### APR1400 Design Certification

Docket No. 52-046

RAI No.: 211-8236  
SRP Section: 09.02.01 - Station Service Water System  
Application Section: 9.2.1  
Date of RAI Issue: 09/14/2015

### **Question No. 09.02.01-2**

Figure 9.2.1-1 Essential Service Water System Flow Diagram

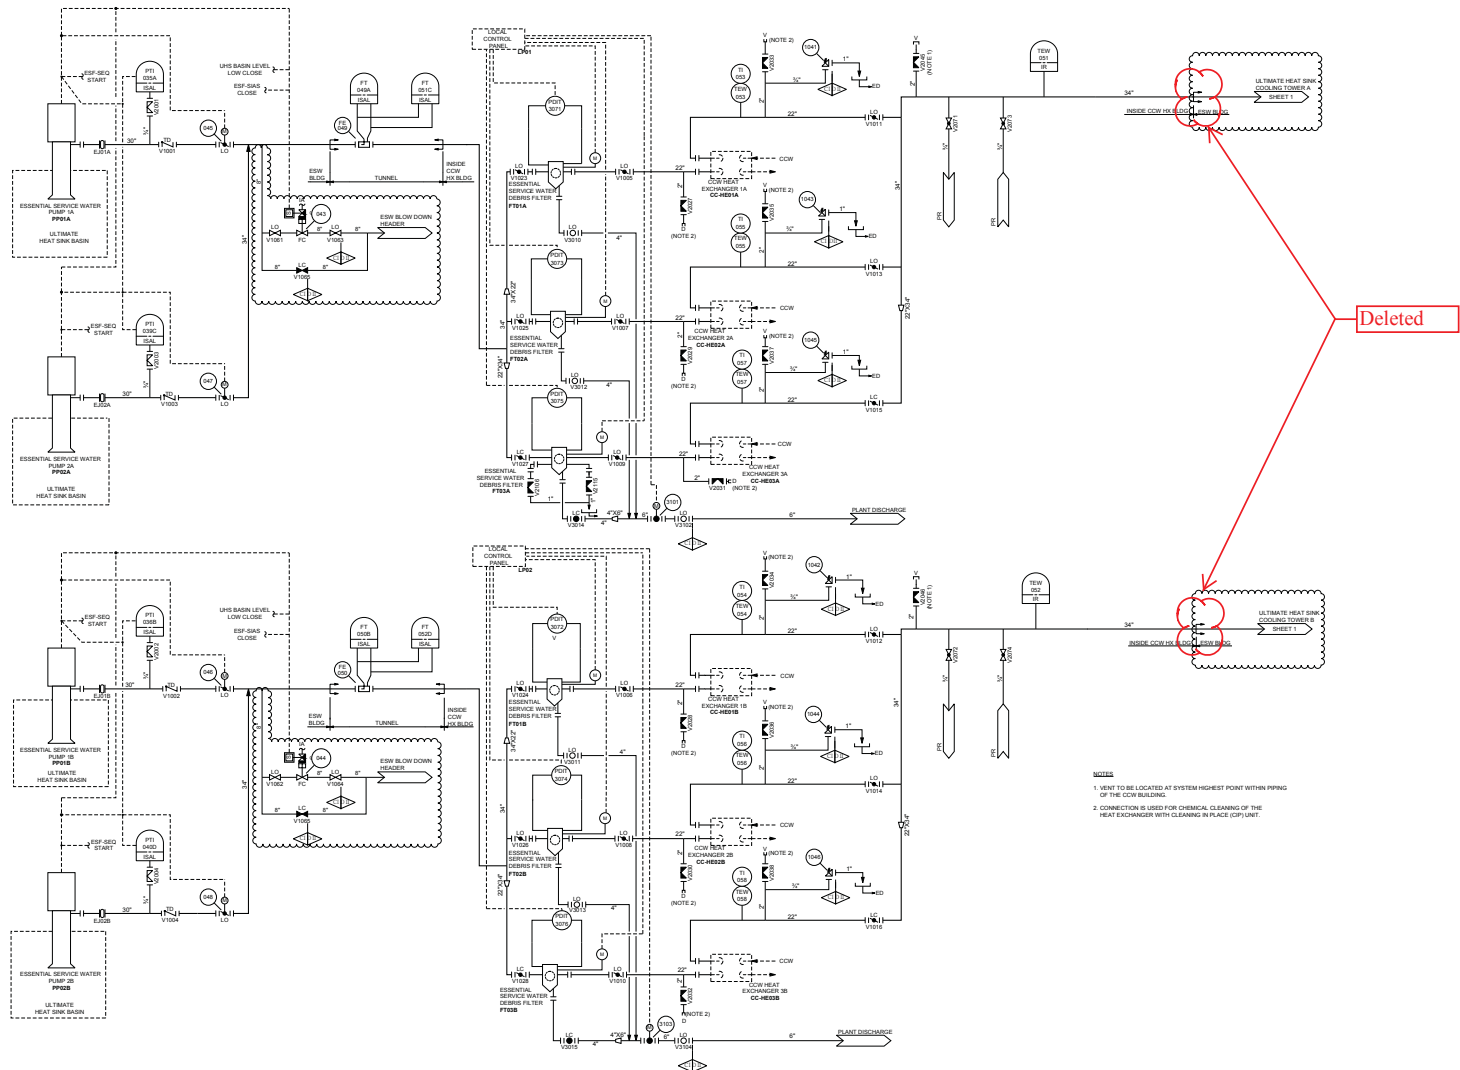
DCD Tier 2, Subsection 9.2.1.2.2.2 will be revised since the ESW is only utilized with the piping tunnel between the ESW building and the CCW heat exchanger building. Also the tunnel symbol on piping upstream of the UHS cooling tower will be deleted in Figure 9.2.1-1.

DCD Tier 1, Table 2.7.2.1-1, and Tier 2, Table 3.2-1, Subsection 9.2.1.2.2.2, and Figure 9.2.1-1 will be revised to show the ESW piping section as shown in attachment.
